# Access Compliance Report

## Public Rights-of-Way

### (Curb Ramps)

Intersection ID: 16557	Main Street: ALLISTER_DR	Cross Street: WALNUT_WOOD_DR	Location:	N
ADA ID: 070B49CD1335	Ramp Type: PerpDiag	Initial Pass/Fail: Fail	Overall Compliance: No	Severity Score: 25

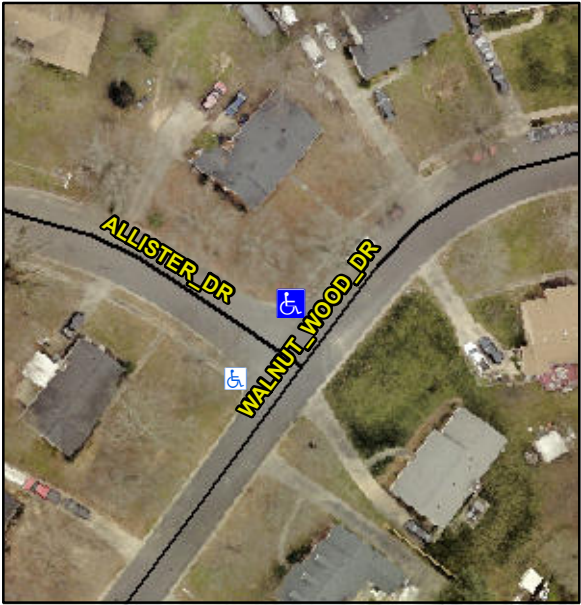
Codes/Mitigation Info/Possible Solution			Field Measurements/Component Compliance		
	Possible Solutions:		<b>Compliance</b>	<b>Description</b>	<b>Data</b>
	<b>Remove &amp; Replace Curb Ramp With Two New Directional Ramps or Equivalent.</b>		N/A	Ramp Length (in)	59.0
			Yes	Ramp Width (in)	48.0
			N/A	Flare Type LT	N/A
			N/A	Flare Slope LT (%)	N/A
			N/A	Flare Traversable LT?	N/A
			N/A	Landing Length (in)	N/A
			N/A	Landing Width (in)	N/A
			N/A	Landing Slope (%)	N/A
			N/A	Landing X Slope (%)	N/A
<p>Surveyor Notes:</p> <p><b>N/A</b></p> <p>PROW/ADA:</p> <p><b>Not Found, R304.2.2</b></p>			N/A	Flare Type RT	N/A
			N/A	Flare Slope RT (%)	N/A
			N/A	Flare Traversable RT?	N/A
			N/A	DWS Provided?	N/A
			N/A	DWS Contrast?	N/A
			N/A	DWS Length (in)	N/A
			N/A	DWS Full Width?	N/A
			N/A	DWS Offset (in)	N/A
			N/A	Shared Landing?	N/A
			N/A	Gutter Ponding?	N/A
			N/A	Gutter Lip Ht (in)	N/A
			N/A	Painted X Walk1?	No

X Walk 1 Direction	To SW
			N/A	X Walk 1 Width (in)	N/A
				X Walk 1 Slope (%)	2.1
				X Walk 1 X Slope (%)	3.1
			N/A	Ramp inside XWalk1?	N/A
				Road Slope (%)	3.3
				Road X Slope (%)	5.5
			N/A	Any Obstructions?	N/A
				Obstruction Type	
Total Cost:		\$ 3200.00			
			N/A		N/A
			Yes	Surface Condition? (G/P)	Good
